Product/Process Change Notice - PCN 24_0146 Rev. -

PCN Title:	ADRF5025 Data Sheet Revision
Publication Date:	03-Jul-2024
Effectivity Date:	03-Jul-2024 <i>(the earliest date that a customer could expect to receive changed material)</i>
Revision Description:	Initial Release.

Data Sheet Revision from Rev-C to Rev-D for ADRF5025:

Figure 2. Power Derating vs. Frequency, Low Frequency Detail, $T_{CASE} = 85^{\circ}\text{C}$

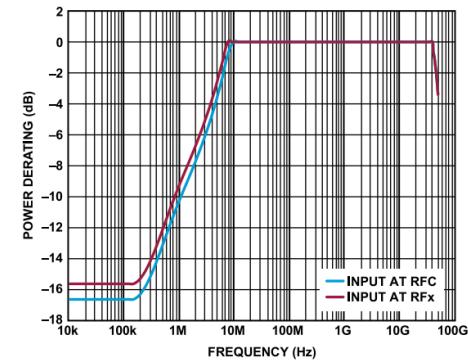
1. Features and general description sections are updated for hot-switching capability description.
2. Electrical table changed for hot-switching specification from 26dBm to 23dBm for RF1 and RF2 ports.
3. Power derating curve for low frequency (Figure 2) updated and reverted back to Rev-B datasheet plots.

Figure 2. Power Derating vs. Frequency, Low Frequency Detail, $T_{CASE} = 85^{\circ}\text{C}$

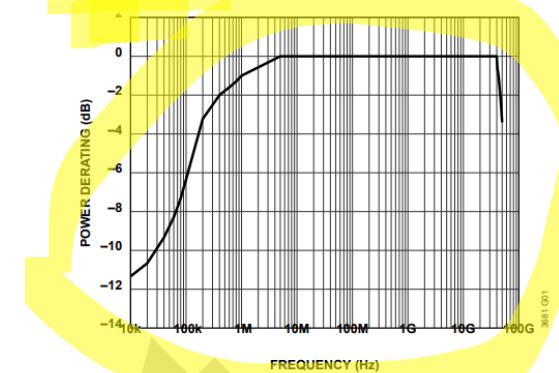
Power derating data shown in [Figure 2](#) and [Figure 3](#) applies to both RFC and RFx pins.

► Plot data is from RevB
